## **TECHNICAL INFORMATION**

ZIB-132

### Re: Expanded Functions for the IC-703

Model: IC-703 (All versions)

#### MAIN BOARD

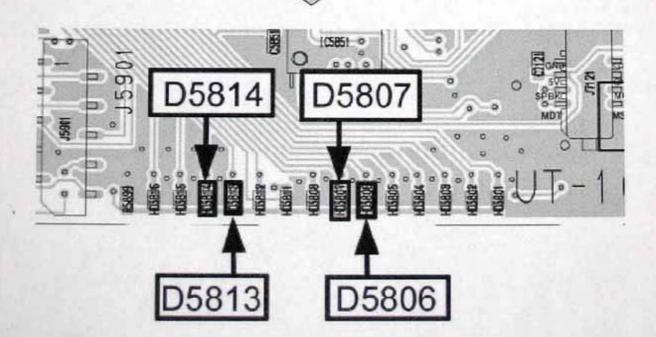
(1) Frequency Coverage (Full TX expansion): 0.100000 – 60.000000 MHz Remove D5806 and D5807 on the MAIN board as shown in the attached diagram.

(2) Frequency Coverage (Normal TX expansion): 1.600000 – 54.000000 MHz Remove D5806 on the MAIN board as shown in the attached diagram.

The following modification cancellations the internal antenna tuner protection system when an antenna with SWR of more than 1:10 is used. The antenna tuner does not switch to through mode. Remove **D5813** on the MAIN board as shown in the attached diagram.

(1) Install a diode (1790001250 MA2S111) to the position of D5814 on the MAIN board.
